City of Wilsonville
Exhibit B1 DB20-0002 et seq

PROJECT #180146.03

Planning Division
Development Permit Application

New 11,400 sf metal building with an approximately 52,700 sf open storage yard.

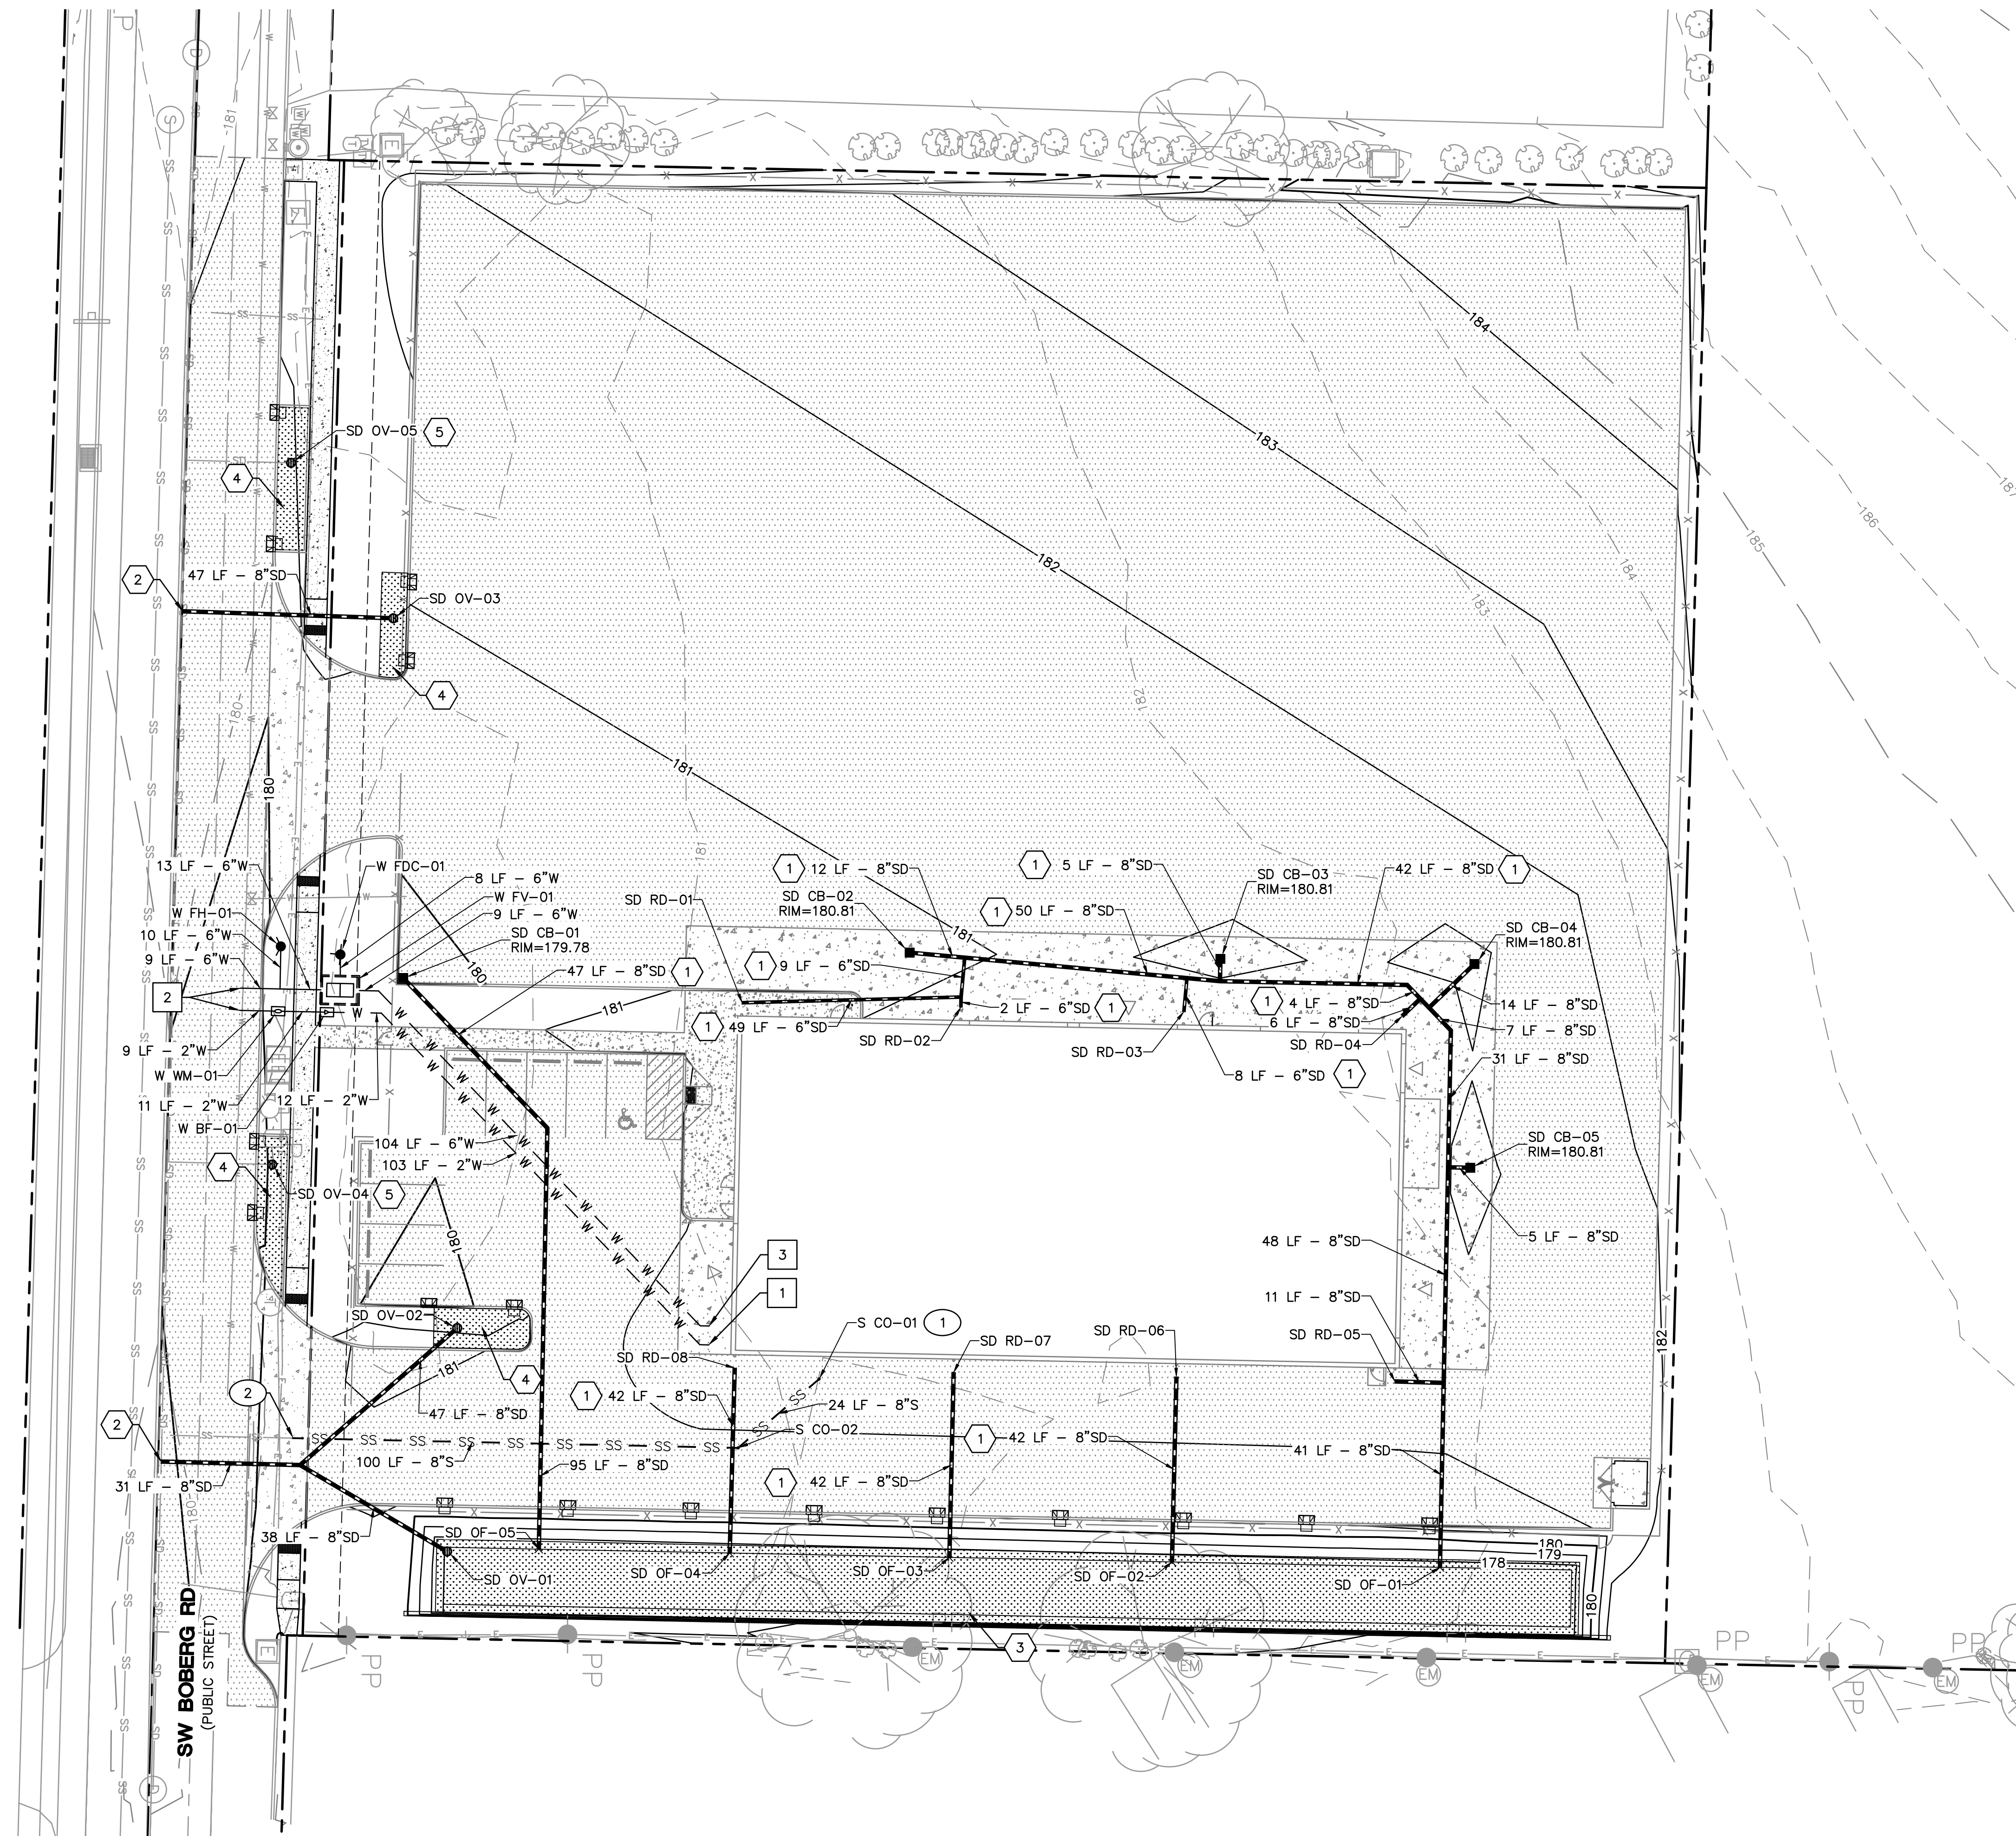
- c. Utility Plan (C3.0)
 - i. Stormwater runoff from outdoor storage area is piped to facility in south landscape area; why not put stormwater facility in southwest corner of outdoor storage area instead?; what is purpose of stormwater facility north of north driveway?

- ii. Is the stormwater line perf pipe or solid?
9. Landscape Plans (L1.01-L1.03)
- a. West side of site
 - i. Walkway from building to sidewalk has a gate; no detail is provided; are ADA or other standards met with walkway design including gate? Does this meet the “safe, convenient connection” test of Section 4.154?

02 RD - 1230 TREE PROTECTION FENCING
NTS

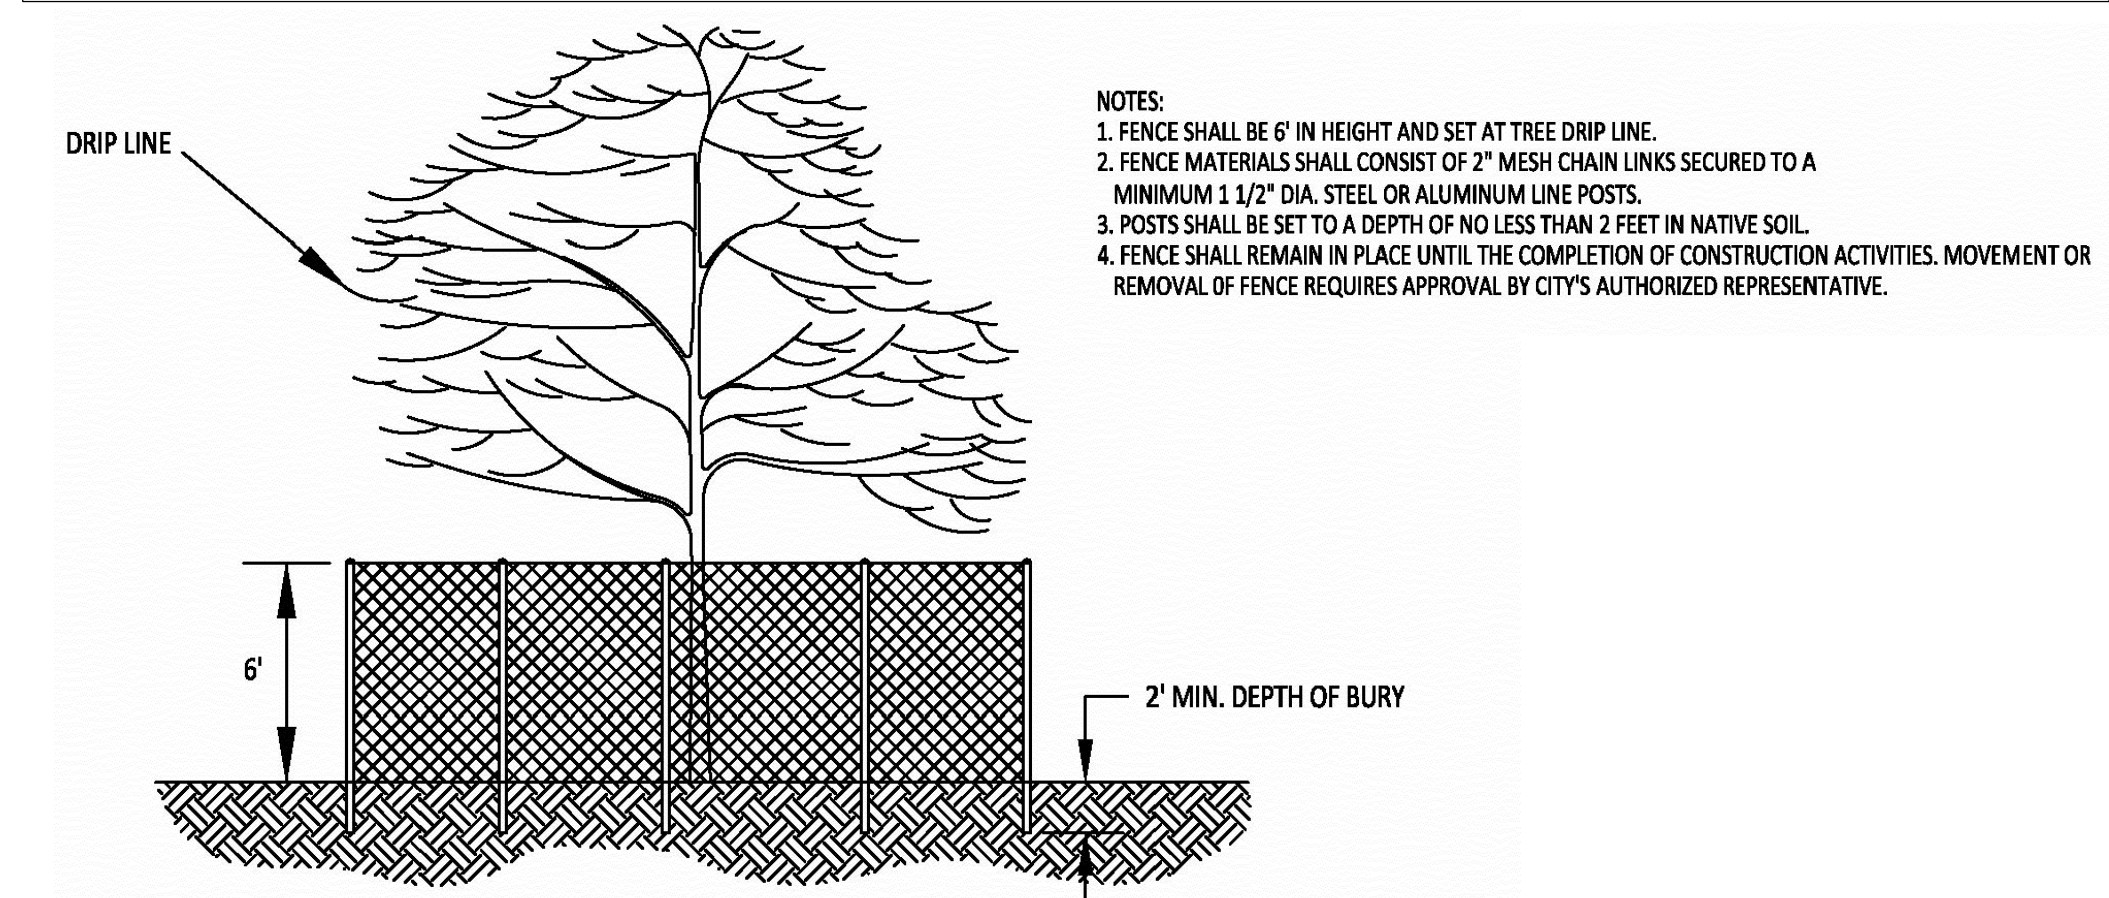
10. Tree Plan (L1.04)
 - a. Protected trees along north property boundary – Show tree protection fencing at drip line of trees
 - b. (02 Detail) Tree Protection Fencing – Incorrect drawing; include correct detail from Public Works Standards (RD-1230)

1 ARCHITECTURAL SITE PLAN
A0.1 1"=20'-0"

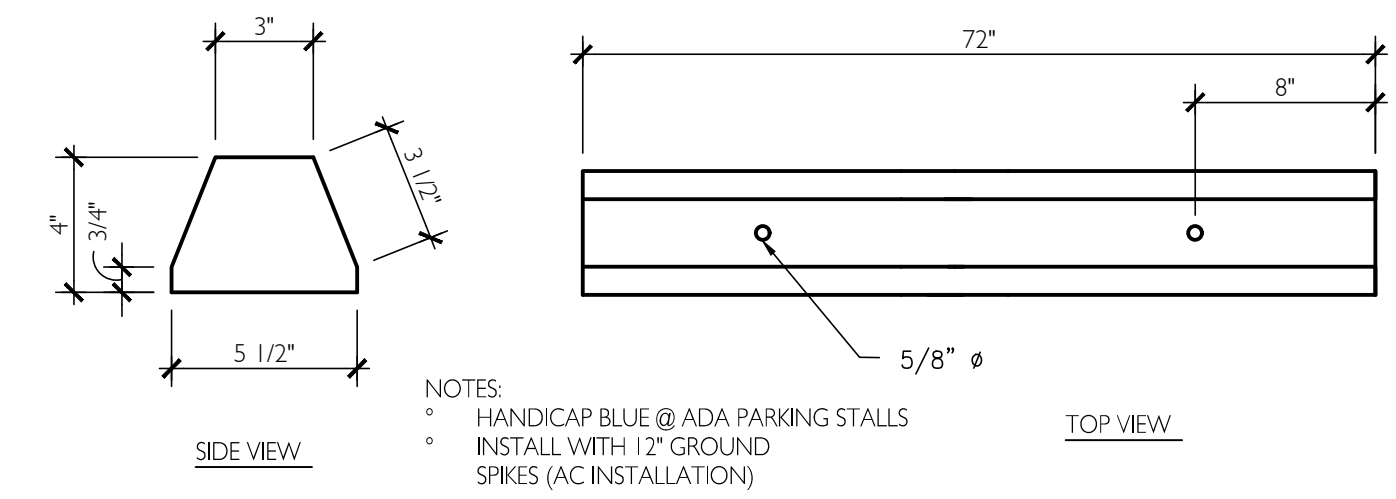
6. Site Plan (A0.1)
 - a. Project Information table
 - i. Building area doesn't add up – 2,000 sf office + 9,376 warehousing = 11,376; total is shown as 11,476

11. Site Plan (A0.1)
 - a. (Note 3) Gates are shown across both driveways; inconsistent with Hardscape Plan (C1.0) which shows only one gate, across north driveway; which is correct?

2. On page A0.1 there is a pad labelled for "wash box" at the north east section of the building. We would like to know if this will be used for washing of equipment and other uses that this area will provide.

2. Plan set has been revised.
 - a. C0.1 & C3.0 are included in package.
 - b. Site plan A0.1 has been revised to include consistent and additional site info.

3
A0.3 CHAIN LINK GATE EXIT DOOR HARDWARE
N.T.S.

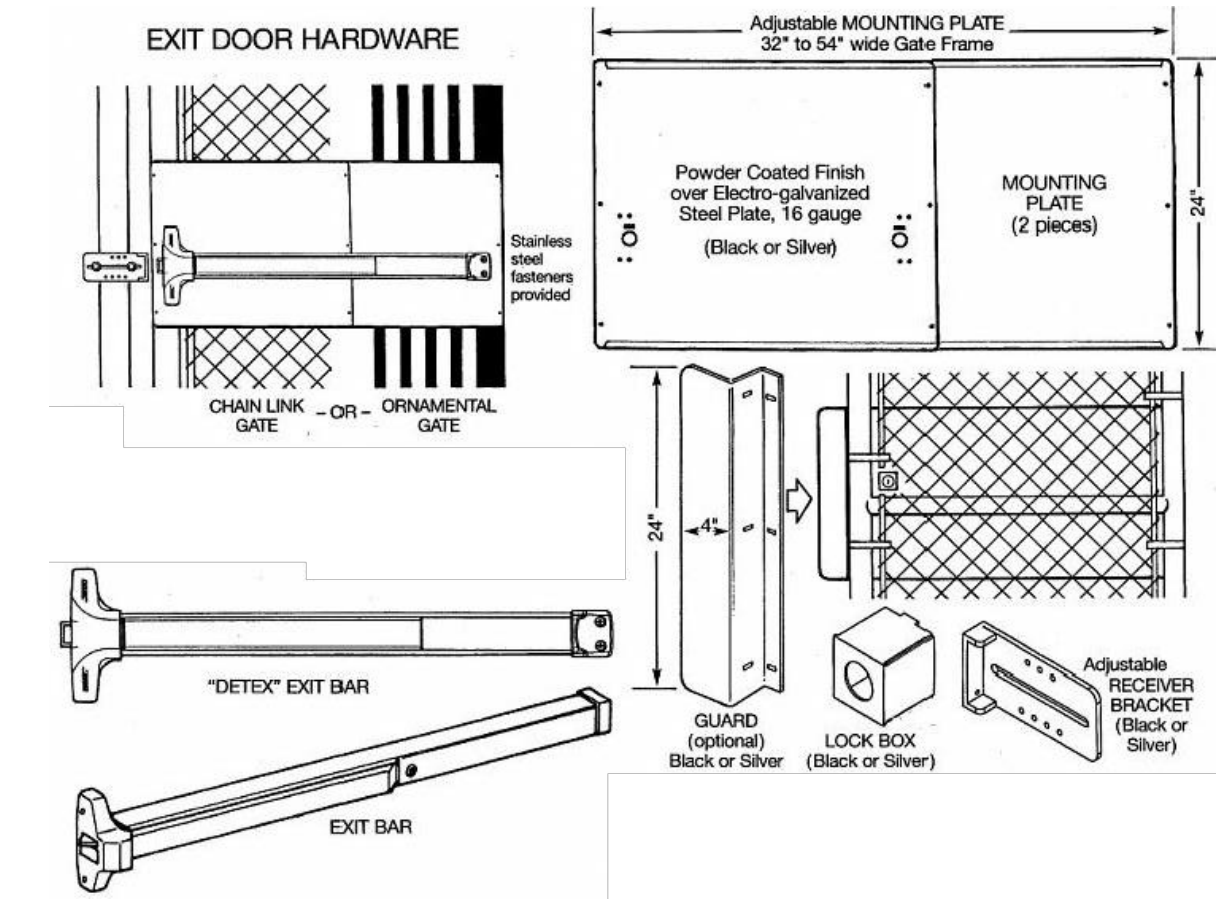
- iii. (Note 16 on C1.0) Gate on walkway and man door in fence by trash enclosure – No detail is provided; are ADA or other standards met with walkway design including gate? Does this meet the “safe, convenient connection” test of Section 4.154?

1. Per the owner's request, the building has been changed to incorporate sprinklers. Frontage calculation will be included on FLSI.
2. The wash box is a closed loop system. No water form system will not connect to sanitary water systems. Refer to provided Wash Bay Recirculation System documents under supplementary information in the narrative.
3. See above.
4. Accessible hardware will be used on gate. Refer to detail 3/A0.3.
